ADDENDUM NO. 01

Project #: PLO26-0005 & CE-6505

Project: Kidd-Davies Dishwasher Replacement
Kingston General Hospital
76 Stuart Street
Kingston, ON
K7L 2V7

E1 OF 4

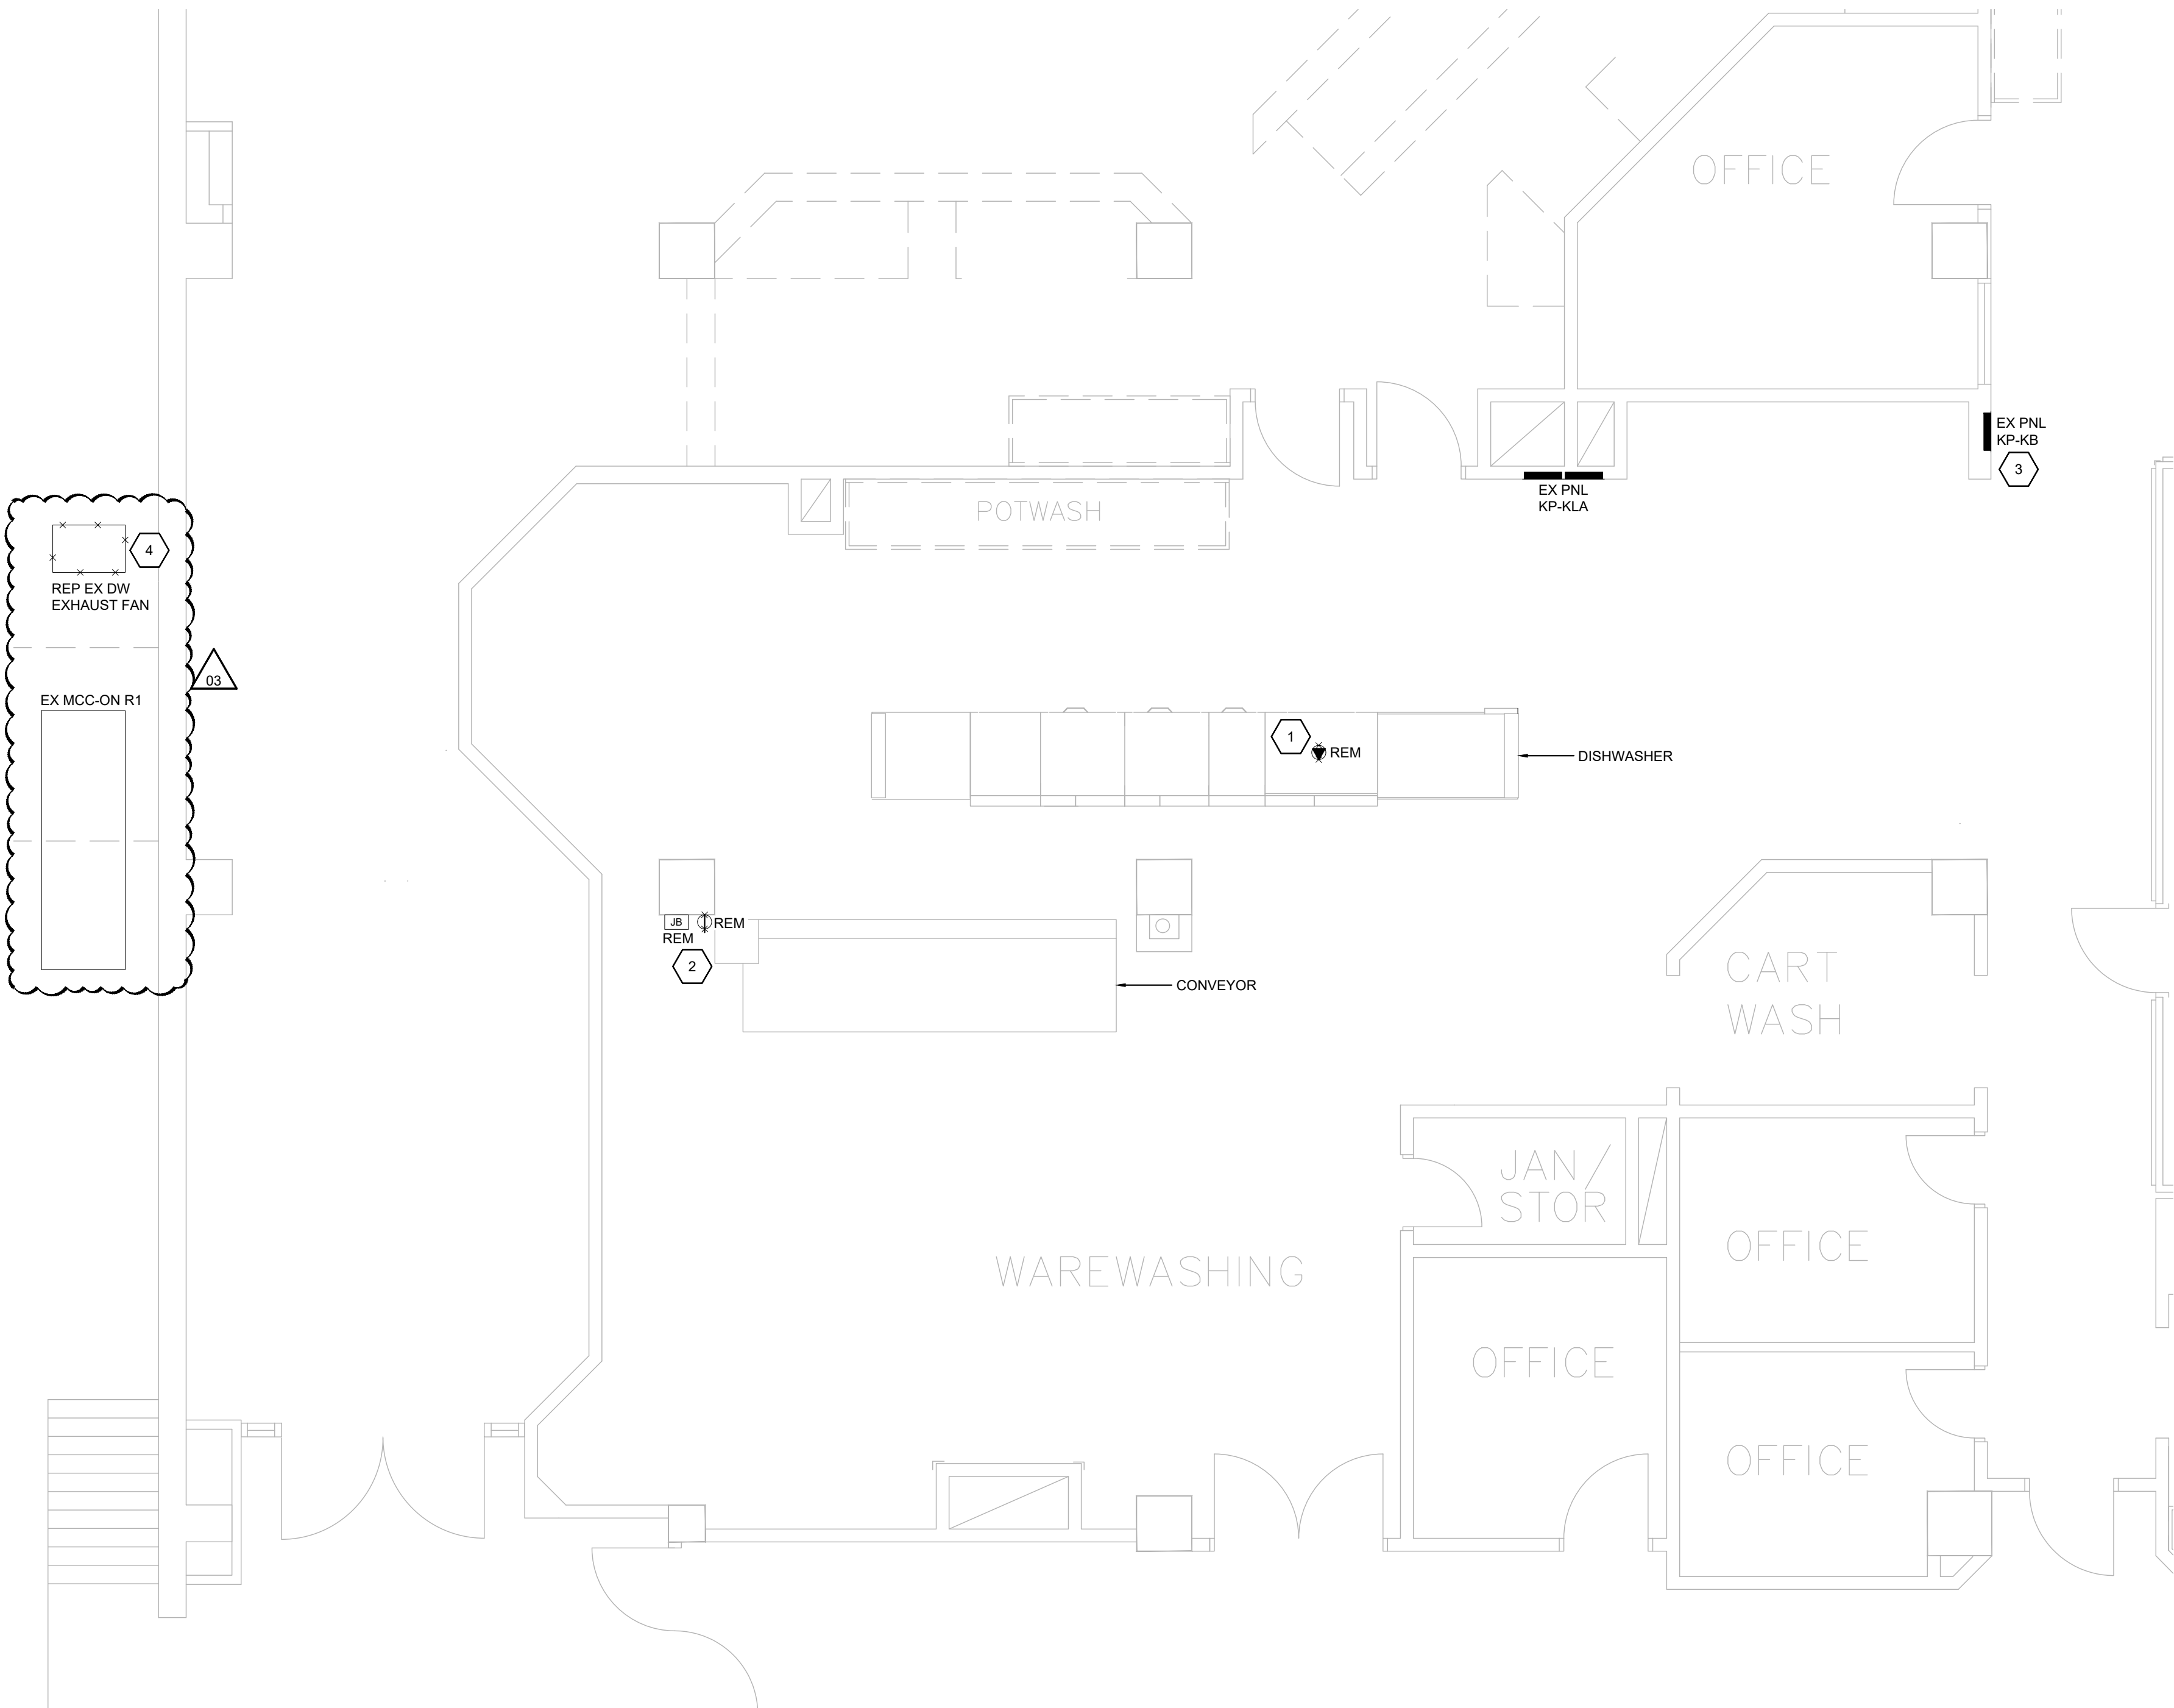
- 3.1. Drawing E1 & E2: **Revise** EF-101 voltage, wiring, source panel and control requirements.
-
